PLANNING COMMITTEE UPDATE REPORT

App Number	22/00923/FUL
Item Number	4
Address	Former Police Station, Church Road, Epsom, KT17 4PS
Proposal	Demolition of the existing police station (Use Class E) and ambulance station (Sui Generis) and erection of a new residential, nursing and dementia care home for the frail elderly (Use Class C2) comprising ancillary communal facilities and dementia care, basement parking, reconfigured vehicular access onto Church Street, landscaping and all other associated works
Author	Simon Taylor

RE: Church Street, Epsom, Hydrogeological Basement Impact Assessment

Figure 2: EA Groundwater level record for St Philomenas Borehole

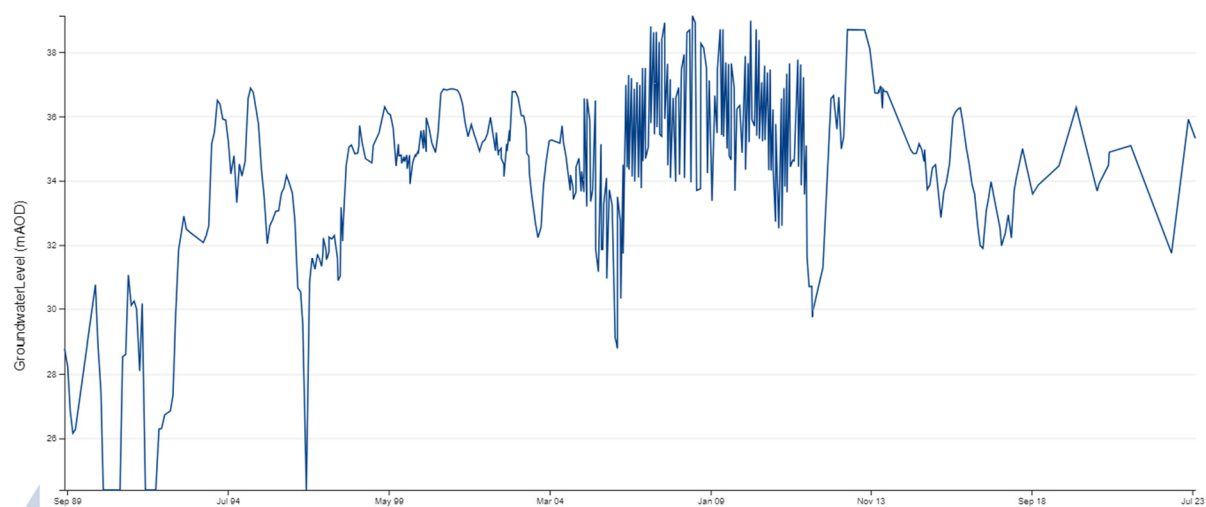
This indicates that since 2000, a groundwater elevation for this location has been between 29m and 39m AOD (averaging around 35mAOD), and also indicating a groundwater fluctuation range extending over 10m. Notably, the record also shows a period of sustained high groundwater elevation of 39mAOD in the winter of 2013 / 2104 which is the same as the reported ground elevation at this location, and therefore indicates likely groundwater flooding from the Chalk aquifer. This event corresponds to the timing of the suspected groundwater flooding incident reported by the residents of No. 50 the Parade.

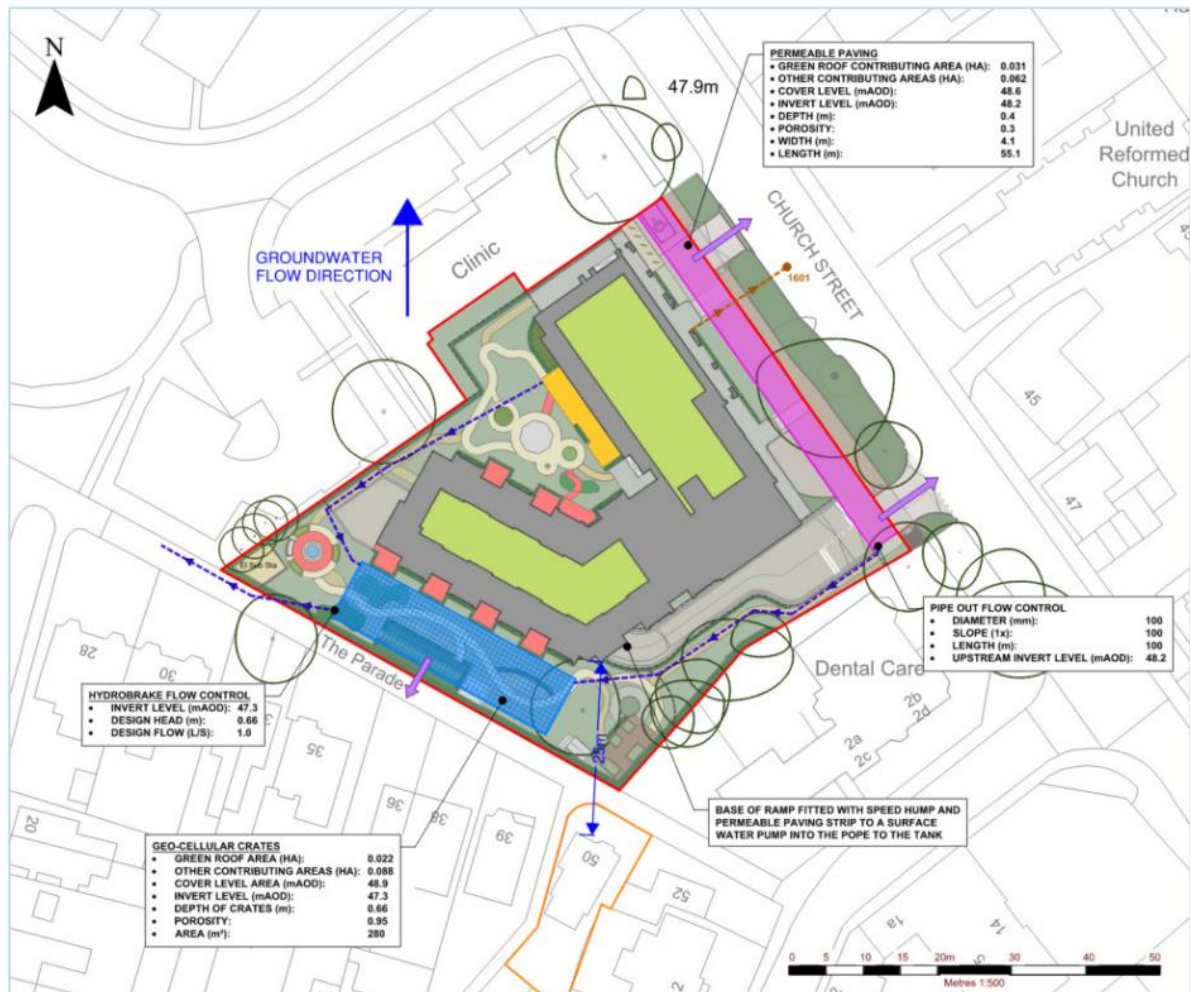
Care home proposal showing position of basement car park in dark grey (footprint of building) plus attenuation tank (in blue) located between the basement car park and The Parade. Also showing assumed groundwater flow direction and distance of proposed basement from our house. NB the attenuation tank is even closer than the basement car park.
